ADDENDUM NO. 02

May 01, 2026

PROJECT: Baton Rouge Terminal Interior Upgrades
9430 Jackie Cochran Dr.
Baton Rouge, LA 70811

ARCHITECT: Washer Hill Lipscomb Cabaniss Architecture (LA) LLC, WHLC Architecture
1744 Oakdale Drive
Baton Rouge, LA 70810

E0.0

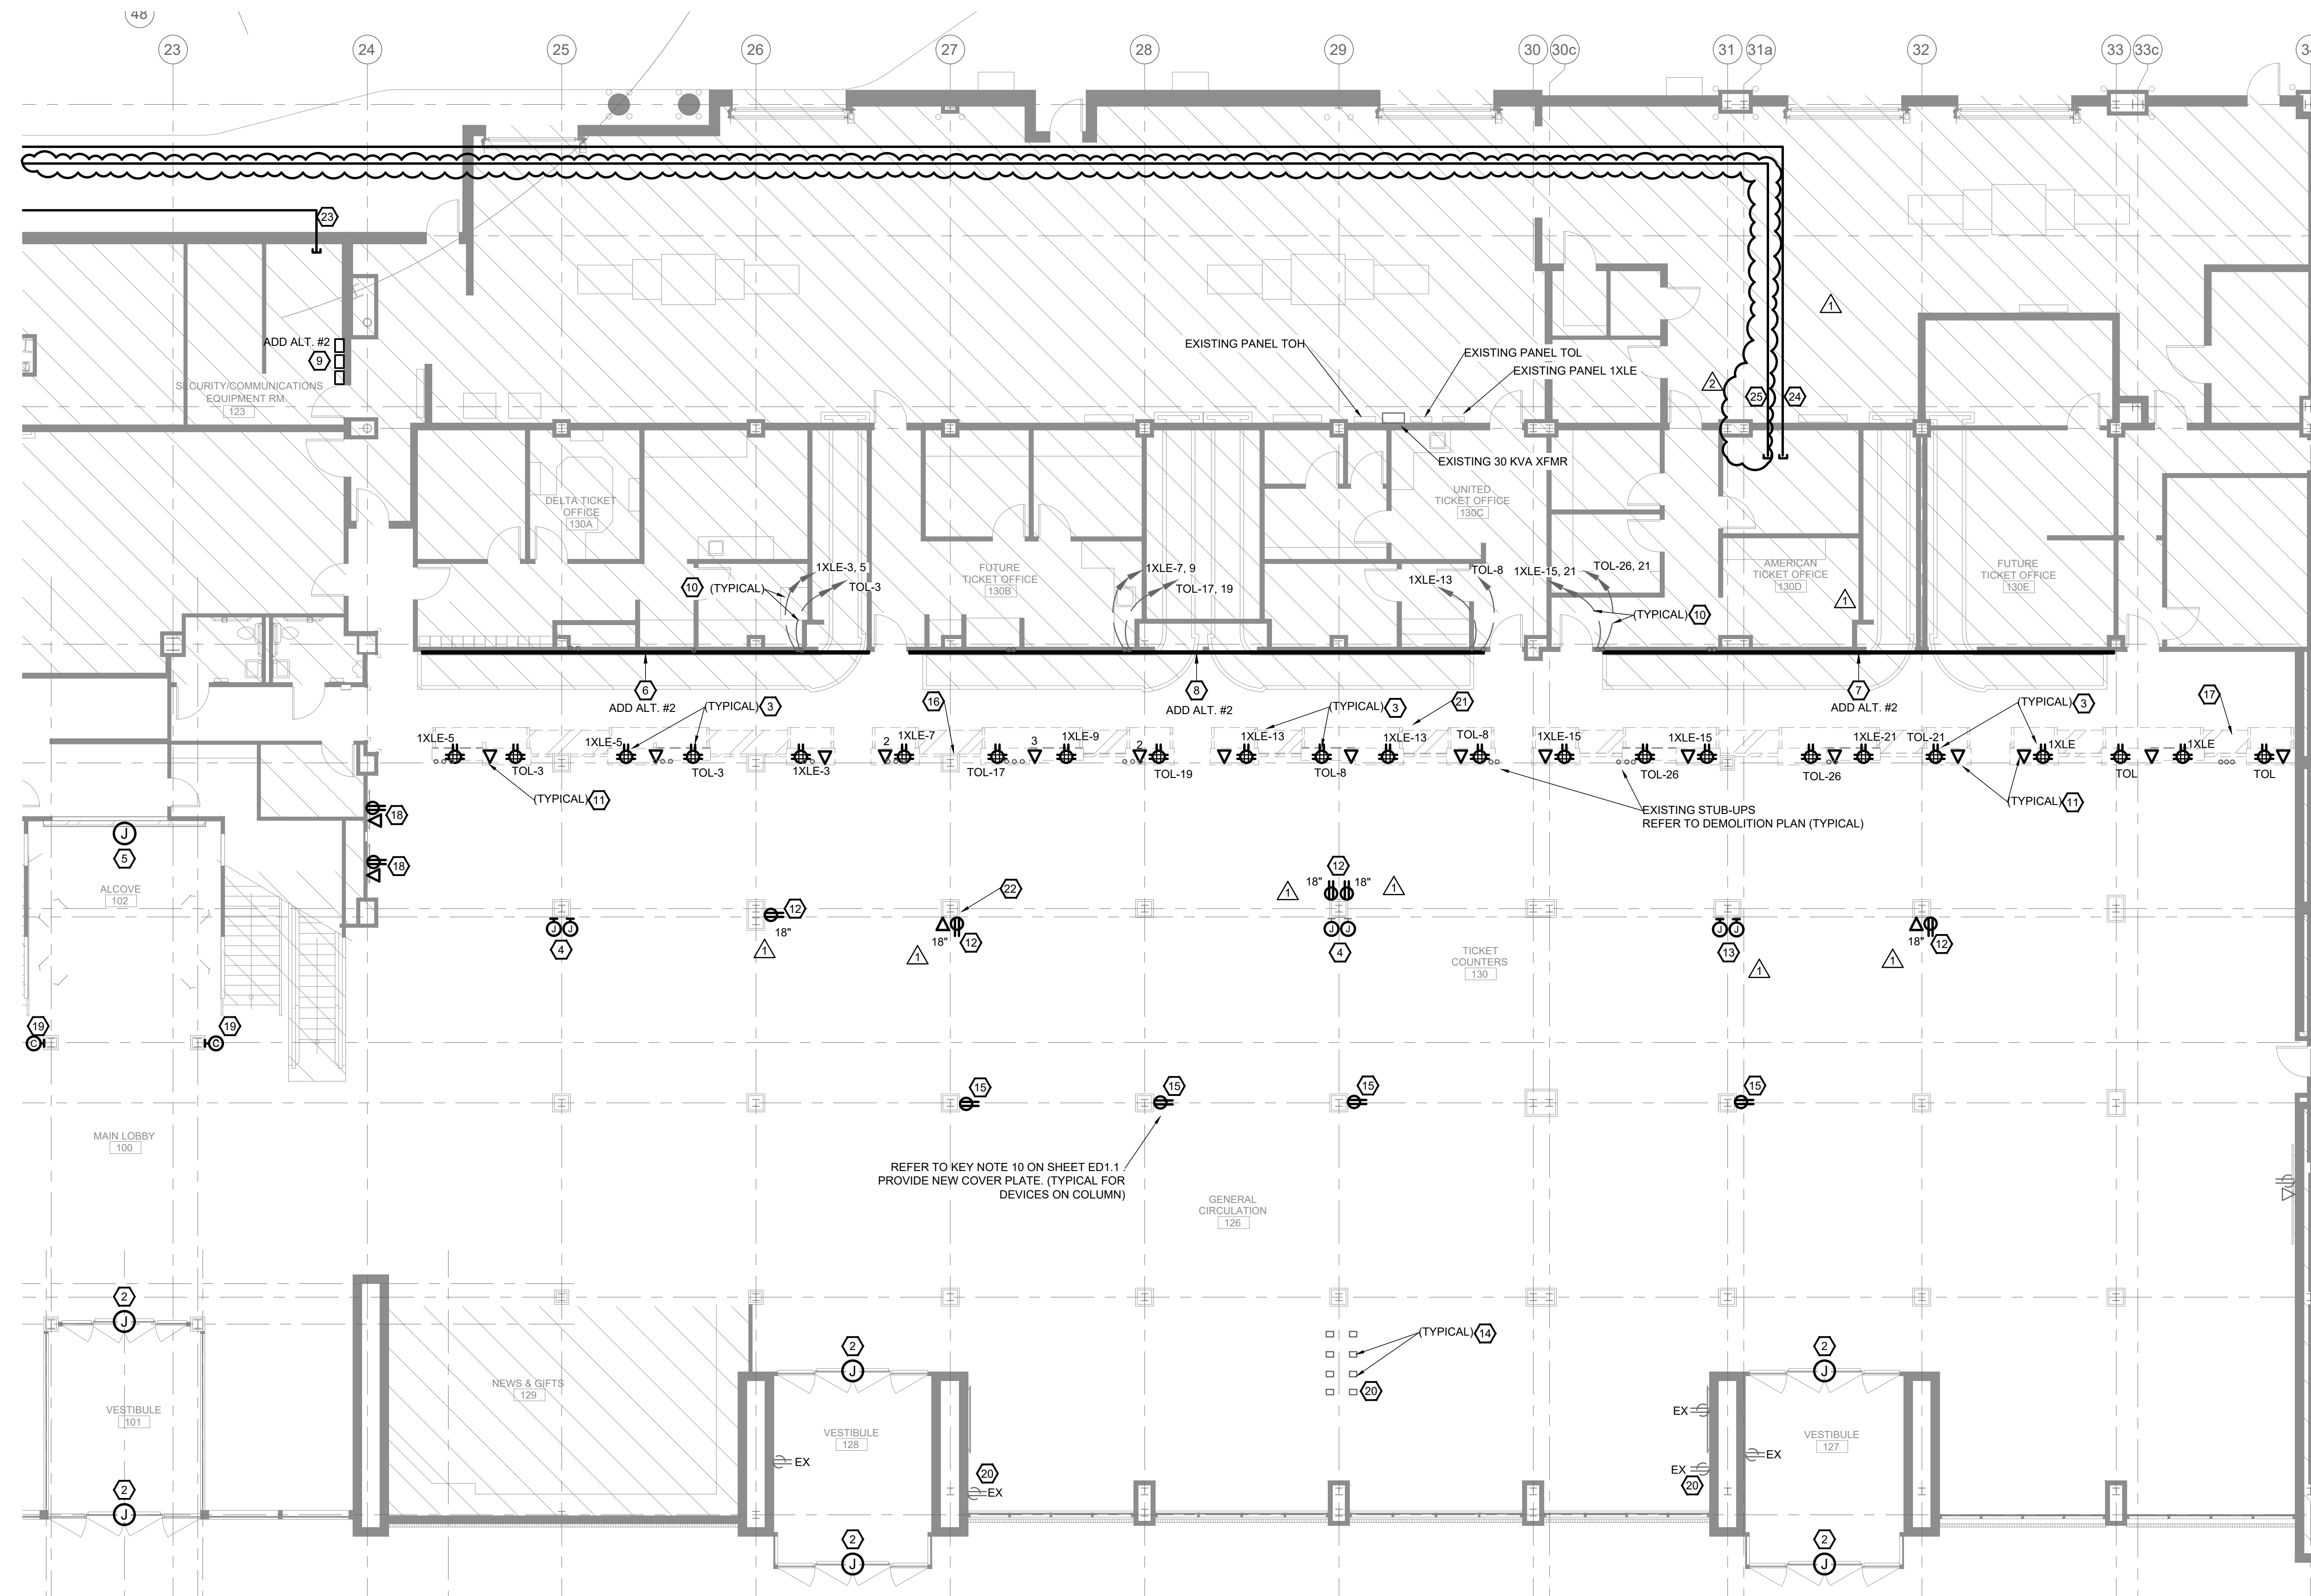
Sheet E0.0: See attached *revised* sheet. **1 page** (24"x36")

LEVEL 1 - TICKET COUNTERS
NEW PLAN

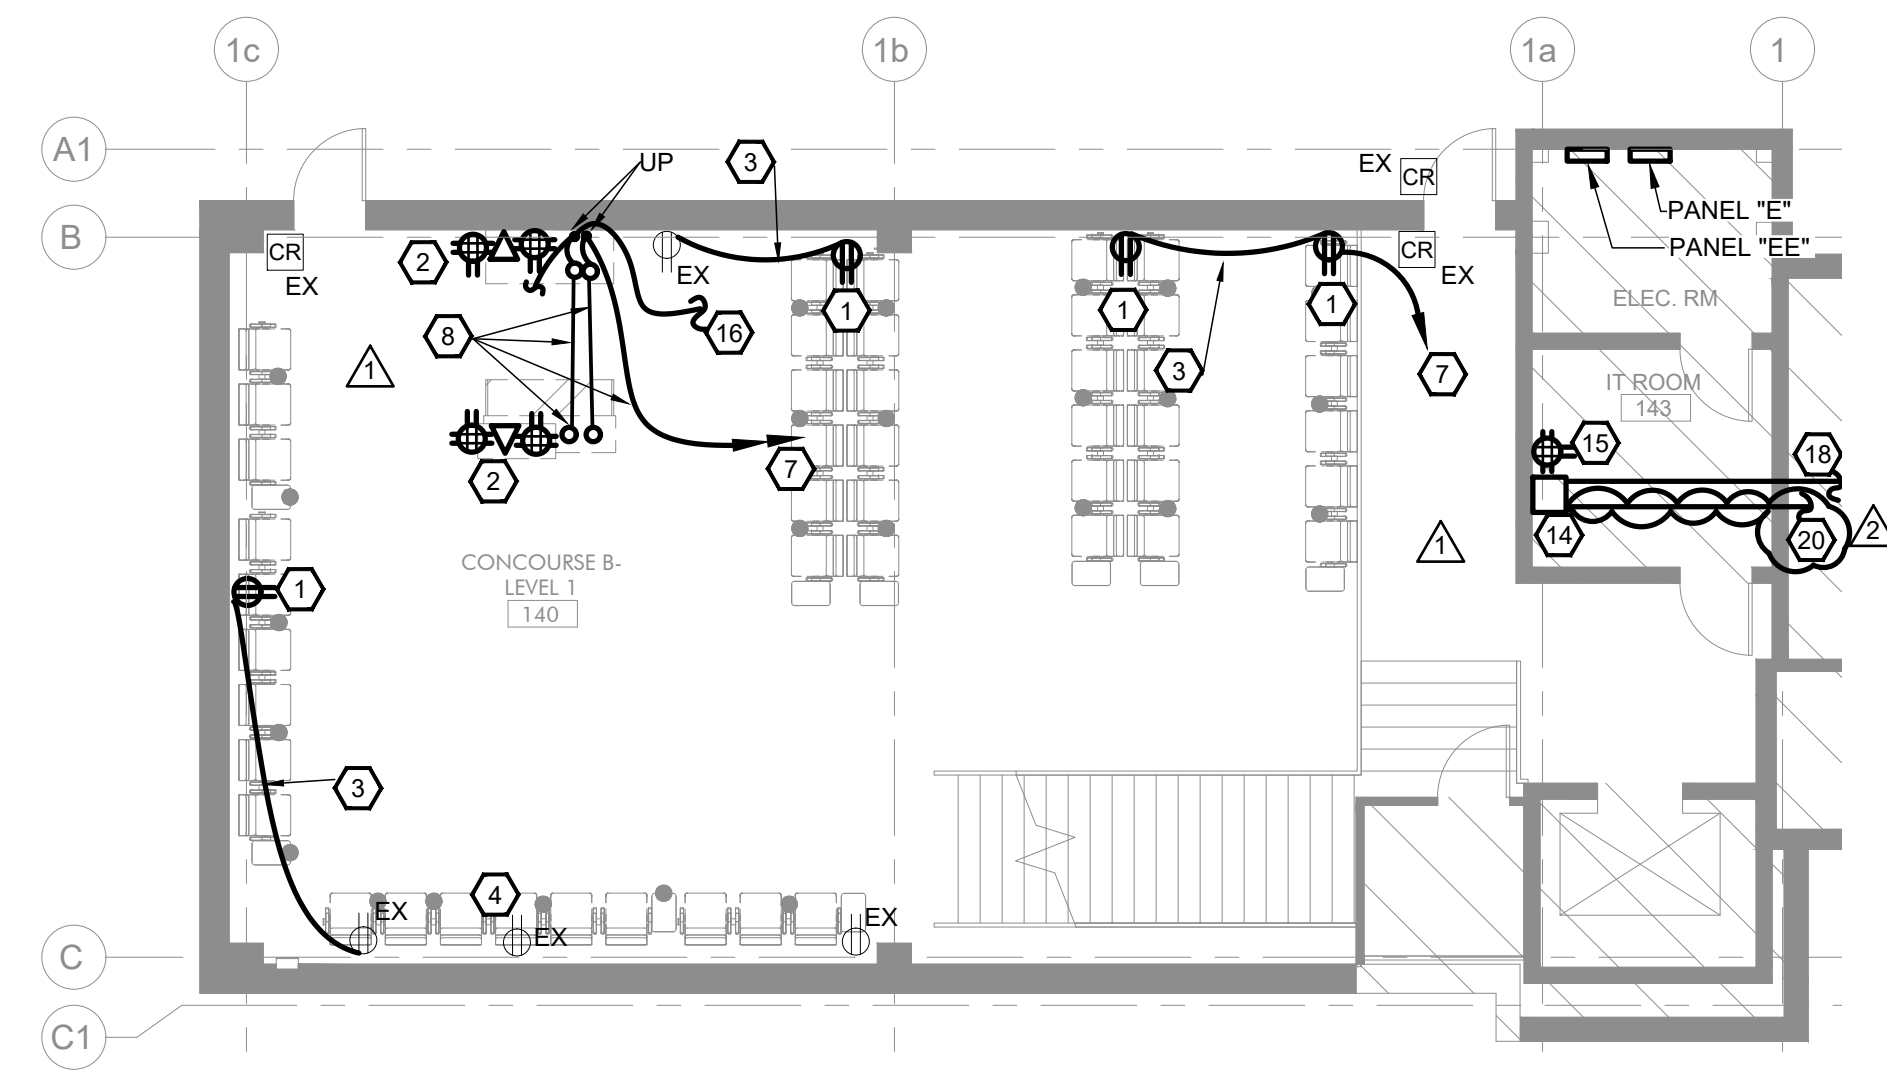
Sheet E1.1: See attached *revised* sheet. **1 page** (24"x36")
